**COMMENTOR NO. 81: STARMET (CONT'D.)  
IDAHO FALLS, IDAHO**

### 3 DOE RESPONSE TO COMMENTS

#### 3.1 INDEX TO DOE RESPONSE TO COMMENTS

Figure 1. Schematic of Depleted Uranium Plasma Conversion Process

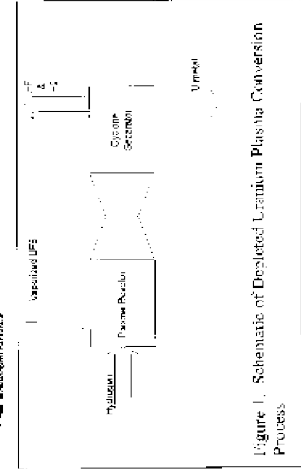
This technology was conceived at the INETI, as a possible method for a lower cost production of uranium metal from UF<sub>6</sub>. Conceptually, the process operates as shown in Figure 1. The UF<sub>6</sub> is injected as a gas into the center of a hydrogen-rich plasma operating at about 5000°C. At this temperature, the UF<sub>6</sub> dissociates to U metal and elemental fluorine. The fluorine recombines with the hydrogen to form HF. As the gas exits the plasma reactor, it must be cooled rapidly to avoid the back reaction of HF with U. At the exit of the reactor, the gas (UF<sub>6</sub> and unreacted H<sub>2</sub>) with the entrained U metal vapor enters a cyclotron where the cooled metal particles are separated from the gas stream. The system operates with excess hydrogen and to maximize conversion of the fluorine to HF. This excess hydrogen must be separated from the HF gas and recycled.
